**PROJECT NAME: Construction Work for Wayne Johnson Community Center**

**BID NO: B191006**

**RE: ADDENDUM #1**

Subject: **MOLD REMEDIATION PROTOCOL**  
Wayne Johnson Community Center/ Carbide Park  
4102 Main Street  
La Marque, Texas

SHEET NO. A101

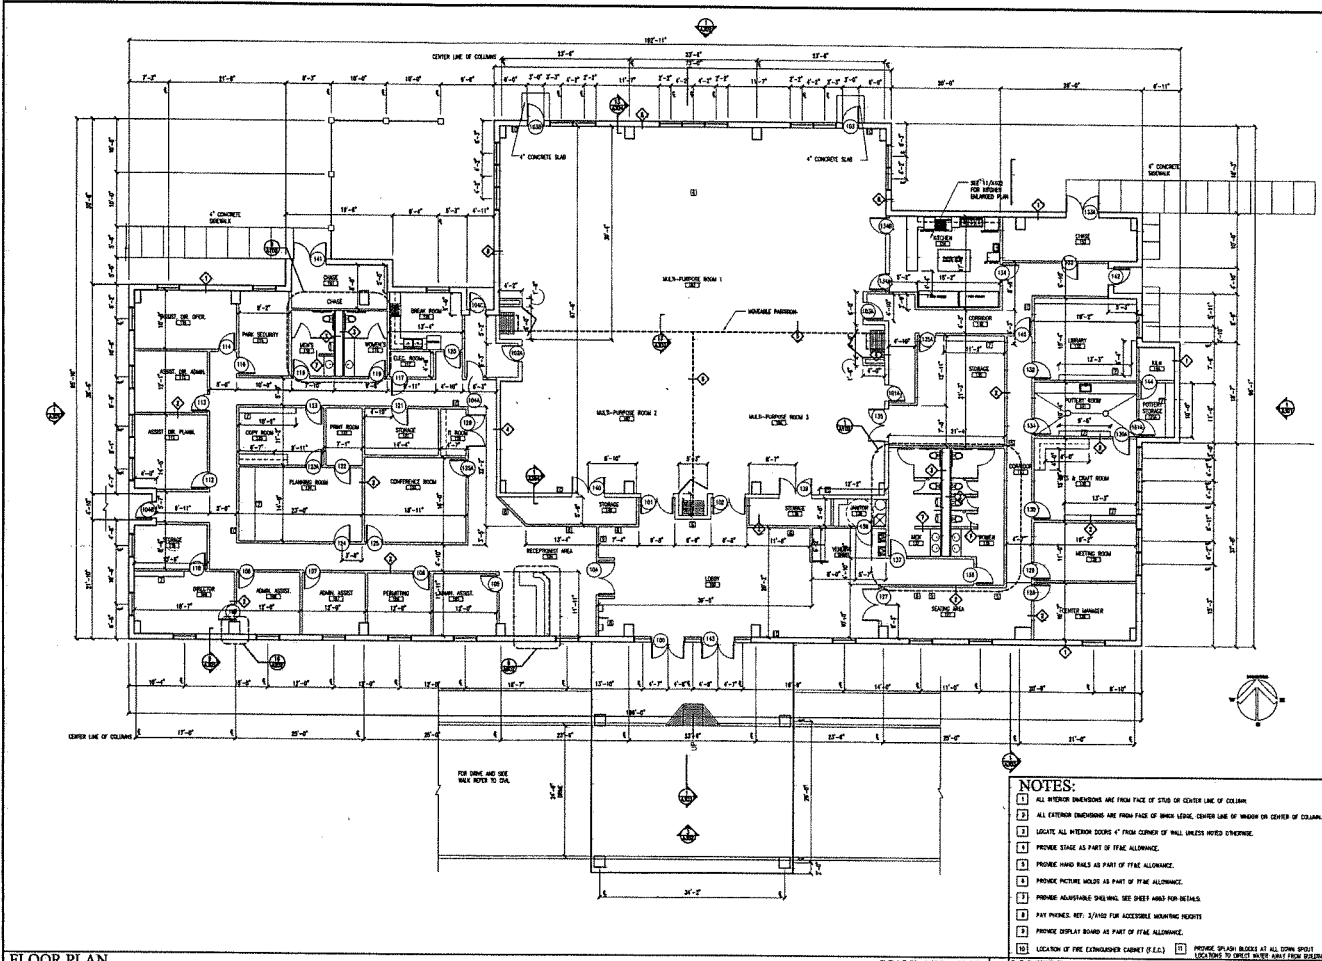
**Question #1:** *Do you have a floor plan drawing of the building that we can use to help us identify work and possible restraints as we walk the site prior to bidding?*

**Response:** Attached you will find the construction plan for the Wayne Johnson Community Center.

### REMEDIATION SCOPE OF WORK DRAWINGS

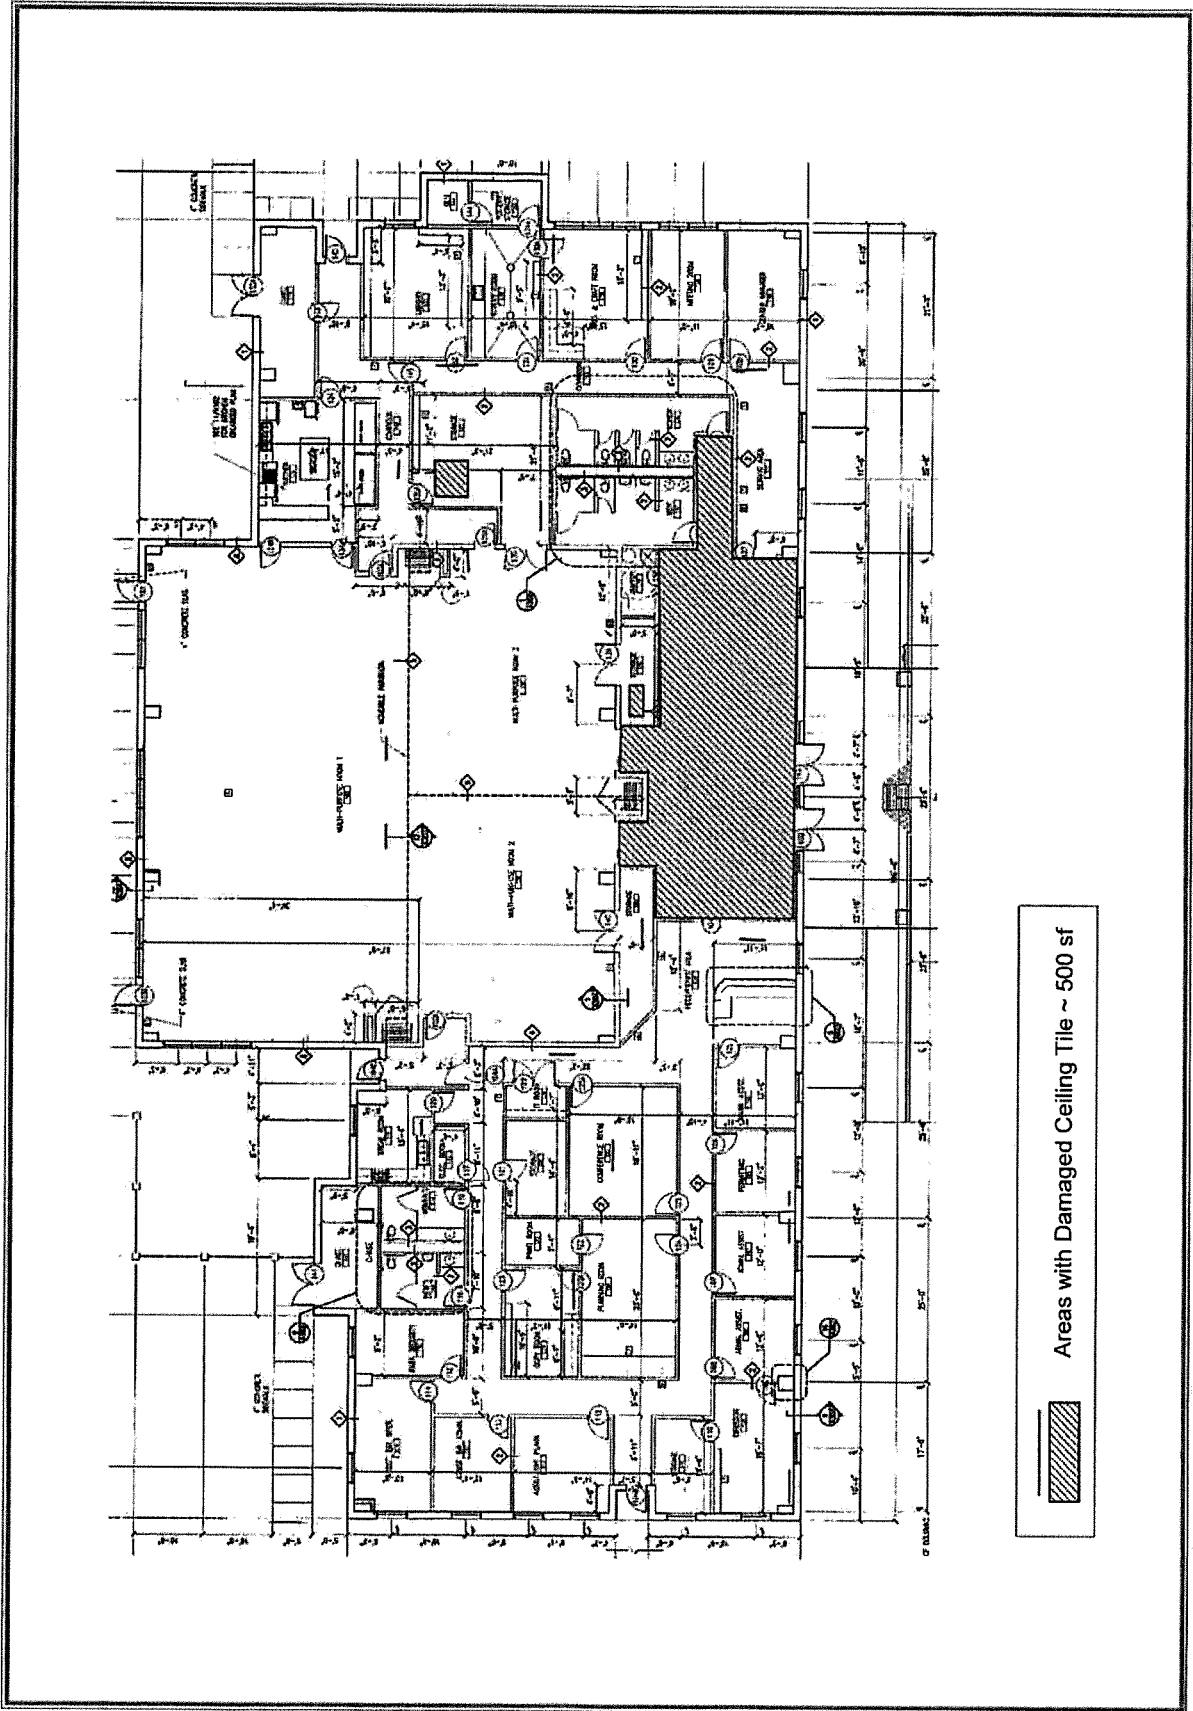
Areas with Damaged Ceiling Tile ~ 500 sf

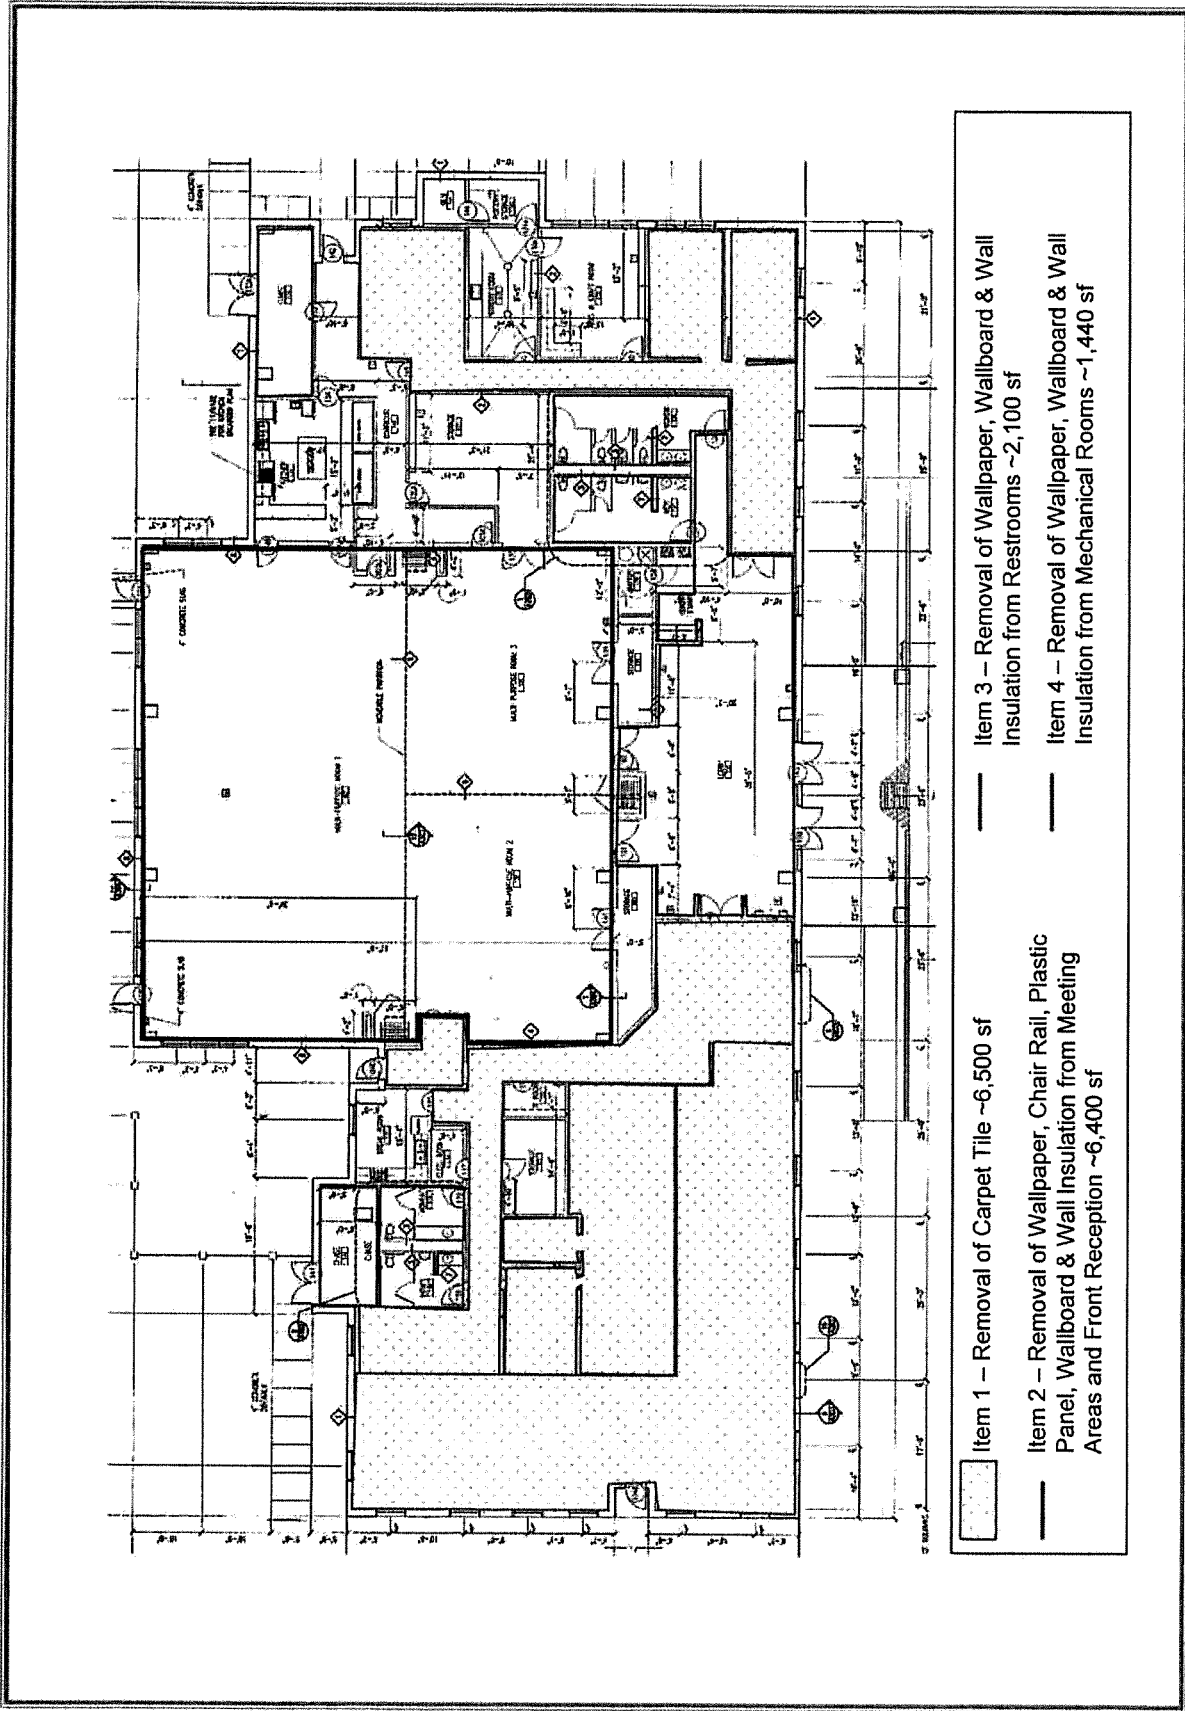
- Item 1 – Removal of Carpet Tile ~6,500 sf
- Item 2 – Removal of Wallpaper, Chair Rail, Plastic Panel, Wallboard & Wall Insulation from Meeting Areas and Front Reception ~6,400 sf
- Item 3 – Removal of Wallpaper, Wallboard & Wall Insulation from Restrooms ~2,100 sf
- Item 4 – Removal of Wallpaper, Wallboard & Wall Insulation from Mechanical Rooms ~1,440 sf
